STAFF ANALYSIS

Case No.: CZ-21-1245234 **Agenda #:** N4

Location / Address: The southwest corner of Midway Road and Beech Drive, at 3446 Midway Road, Decatur, Georgia. **Commission Super District:** District: 3 & 7

Request: For a Major Modification of the conditional site plan and other conditions of RSM (Residential Small Lot Mix) zoning approved pursuant to CZ-18-22025, for six single-family homes.

21-216-CSP02

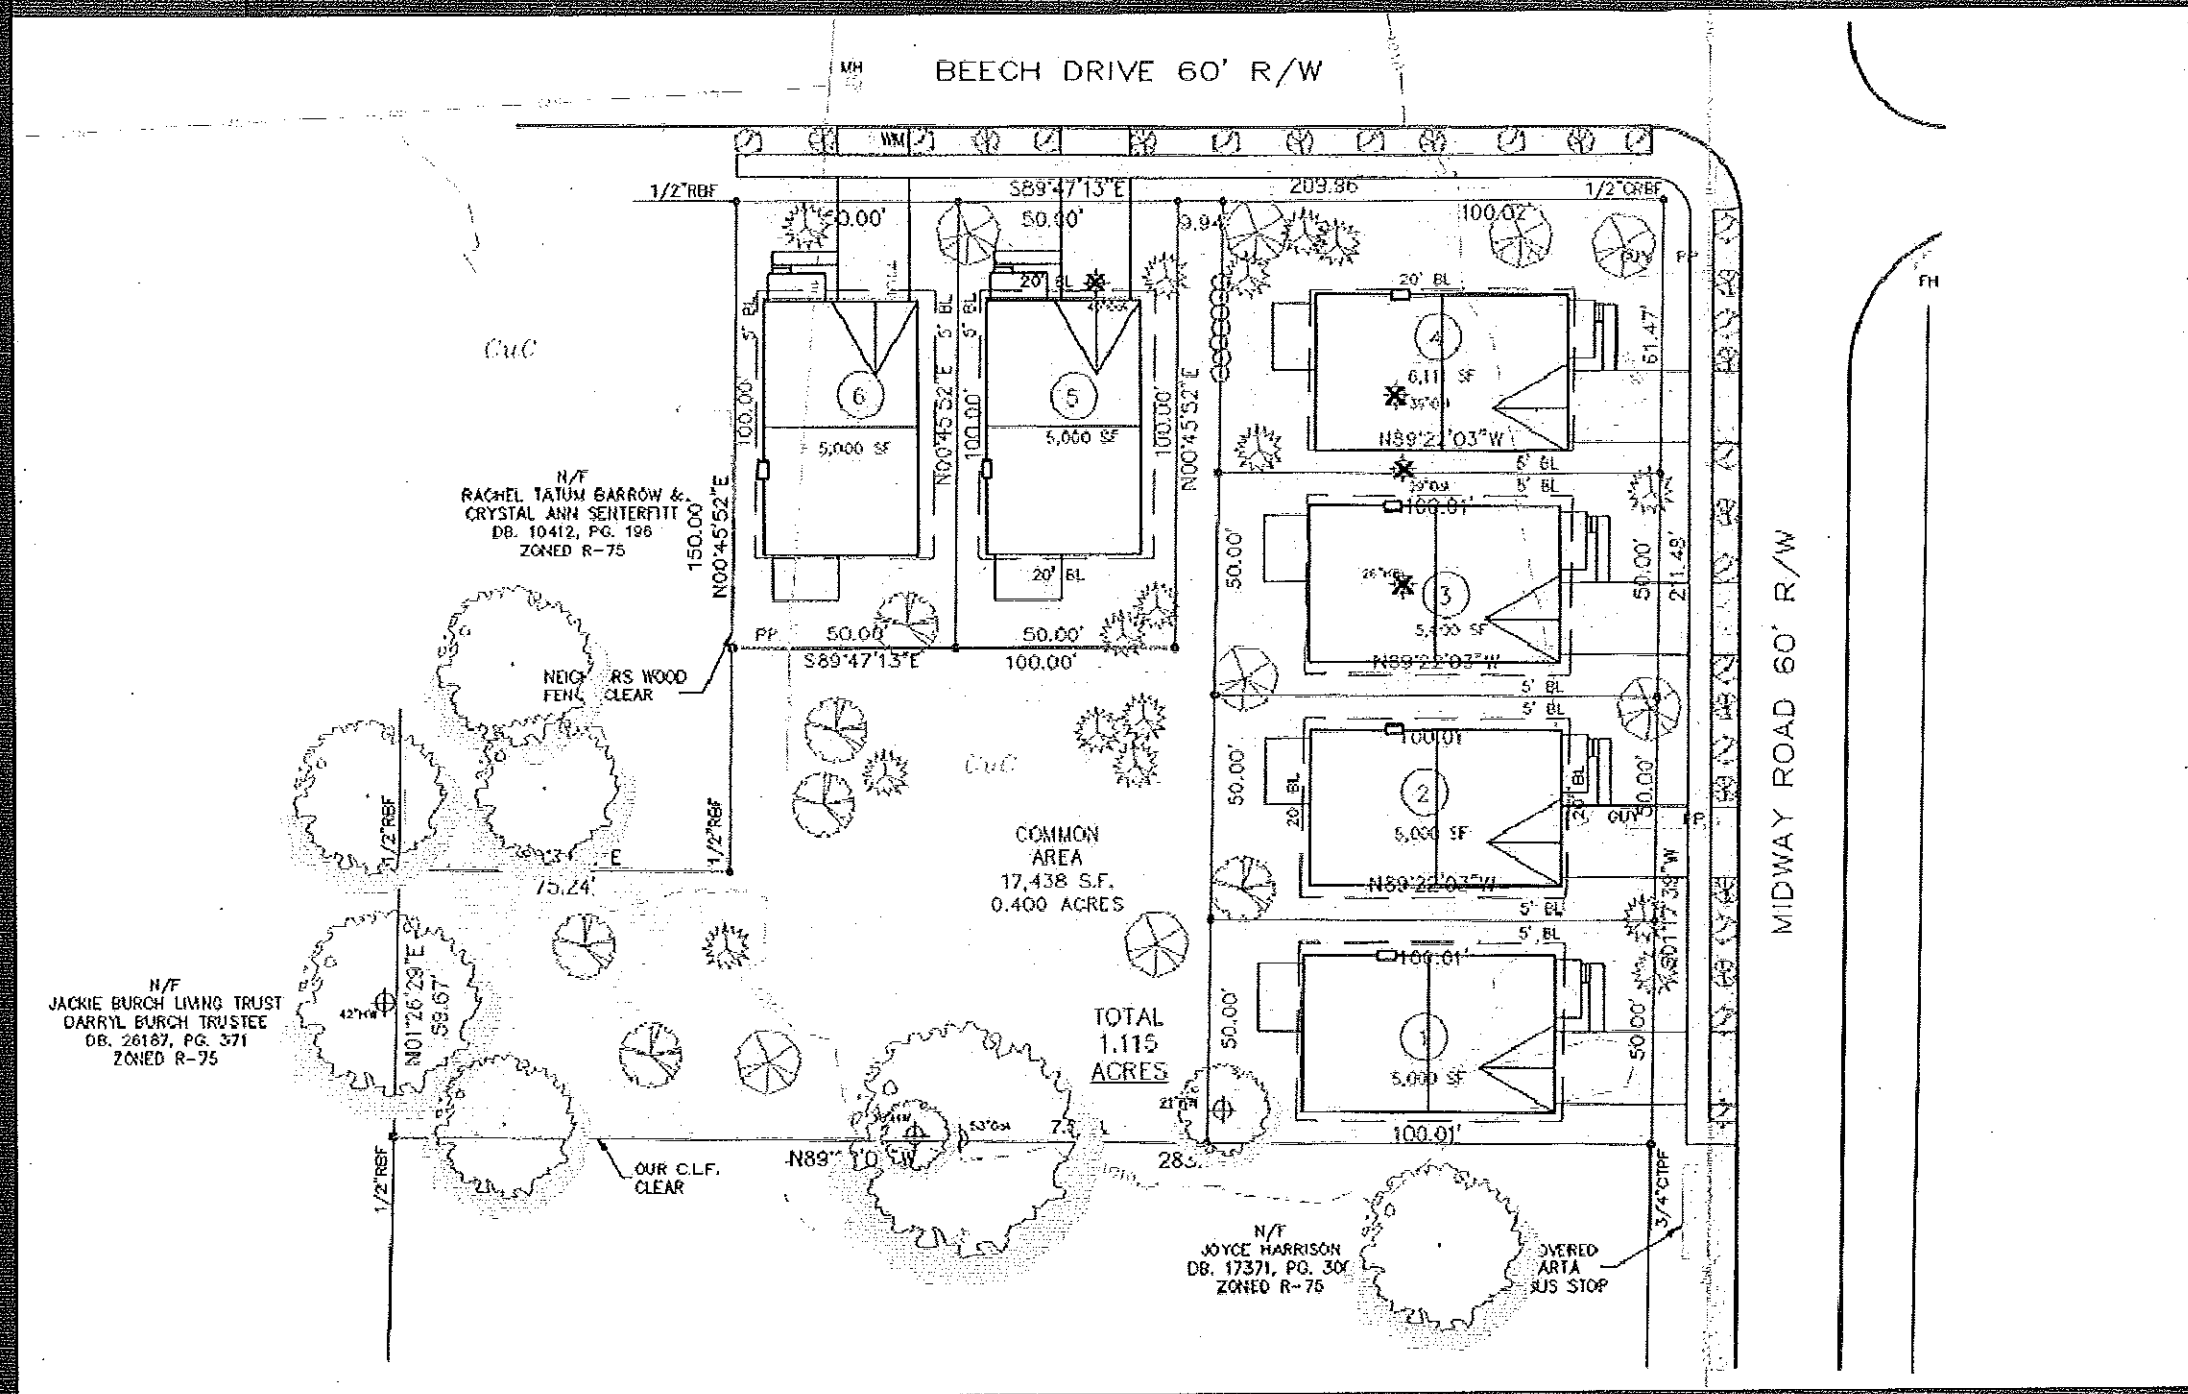
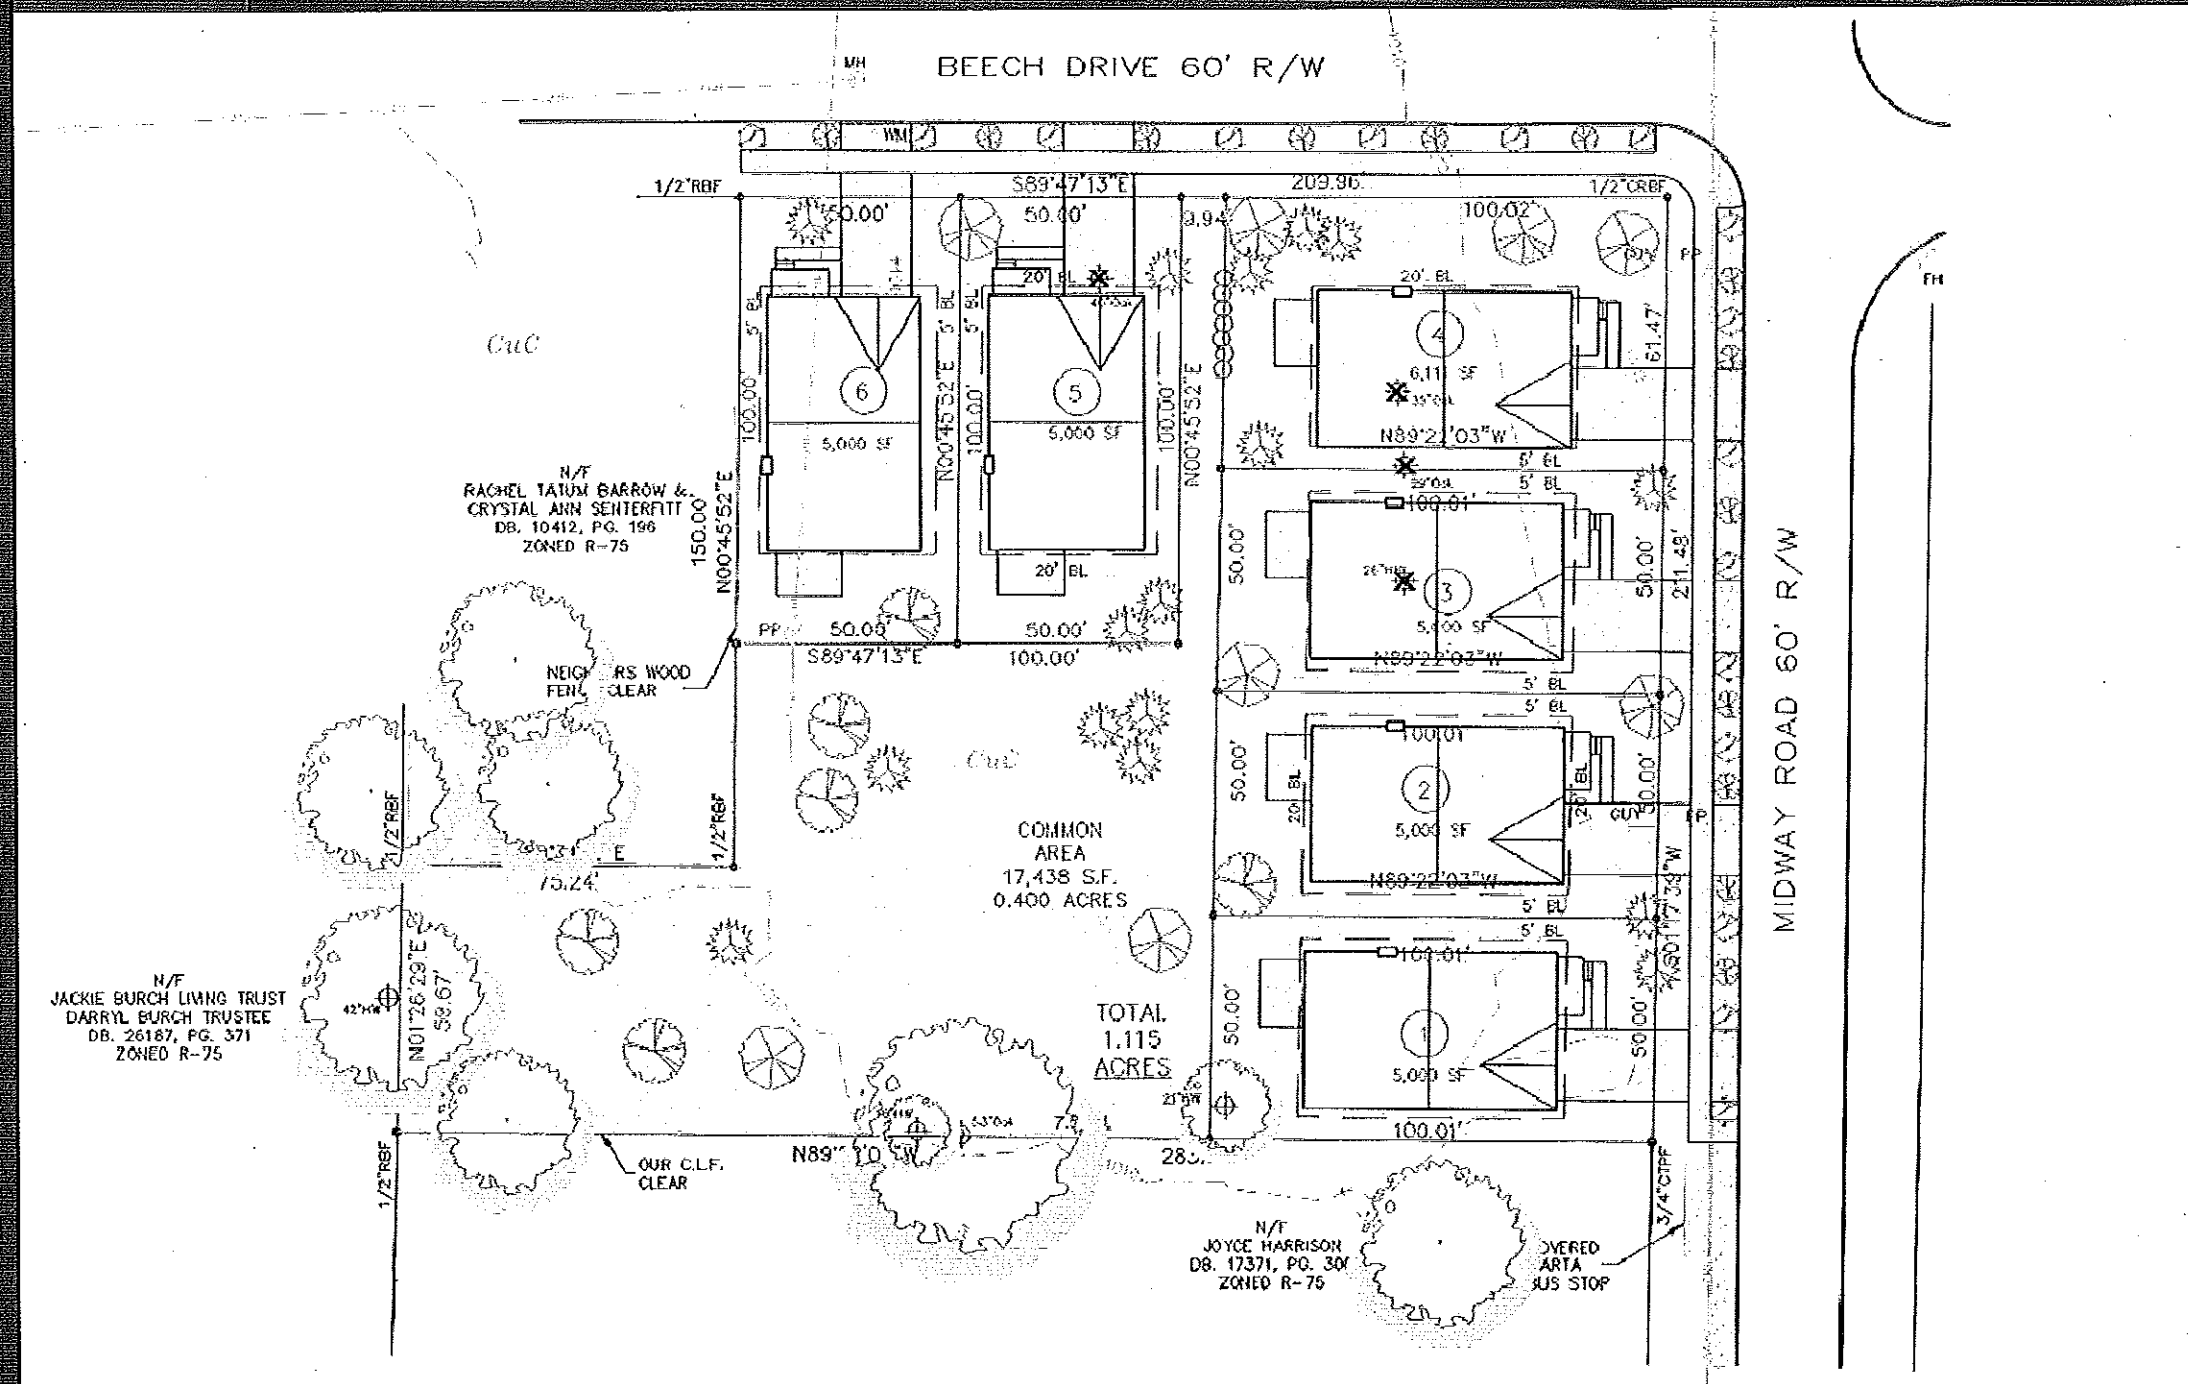
The request is to modify the existing zoning conditions within the RSM zoning district that the Board of Commissioners approved in 2018 per CZ 18 2125 (see attached) to maintain the previously approved number of single-family, detached homes (six units), but to re-orient those units so that their front facades face Midway Road and Beech Road instead of constructing the units on a new internal private street. While the proposed modification request to re-orient the front facades of the homes to face Midway Road and Beech Road appears to be a more neighborhood friendly design than a gated community, there are transportation issues that need to be addressed relating to the increased number of driveways on Midway Road, and the close proximity of the northern driveway to the Midway Road/Beech Drive intersection. The plans

need to show more enhanced open space features to demonstrate compliance with the enhanced open space requirements of the Zoning Ordinance. Additionally, the application needs to address the impact criteria of Section 7.3.5. relating to compatibility with surrounding uses, transportation impacts, etc and provide more justification for the reason for the modification request needs to be provided. Therefore, it cannot be determined if the proposal is compatible with the surrounding single-family subdivisions on adjacent and nearby properties (Sec 7.3.5.B). It is the recommendation of the Planning and Sustainability Department that the request to "Deferred" to allow these issues to be addressed.

STANDARD	RSM REQUIREMENT	EXISTING/PROPOSED	COMPLIANCE
MAX DENSITY	4-8 units per acre maximum	5.35 units per acre with two 50% density bonuses: A enhanced open space bonus and a certified Earthcraft home for all proposed residential units.	Yes, but need to provide revised plan that shows enhanced features such as trail and gazebo/picnic areas
LOT WIDTH	50 feet	50 to 60 feet	Yes
LOT AREA	5000 s.f. (Min.)	5,000 s.f.	Yes
MAX. LOT COVERAGE	50%	54.7%	Yes
FRONT SETBACK	Min 20 ft from Midway Rd Min. 20 ft from Beech Rd	20 ft	Yes
REAR SETBACK	20 ft.	20 ft	Yes
SIDE SETBACK	3 ft. with min. 10 feet separation between buildings	10 ft with 20 ft separation between buildings	Yes
MAX. BLDG. HEIGHT	35 feet	2 stories/28 feet	Yes
MIN OPEN SPACE	20%	35%	Yes.
MIN UNIT SIZE	1,200 s.f.	2,100 s.f.	Yes
MIN ENHANCED OPEN SPACE	35%	35%	Yes, but need to provide revised plan that shows enhanced features such as trail and gazebo/picnic areas

Based on the submitted site plan and information, there are transportation issues that need to be addressed relating to the increased number of driveways on Midway Road, and the close proximity of the northern driveway to the Midway Road/Beech Drive intersection. There has been no indication from reviewing departments and agencies that the proposal could cause excessive use of utilities or schools. The applicant will need to obtain a sewer capacity letter from the Department of Watershed Management to verify if sewer capacity is available.
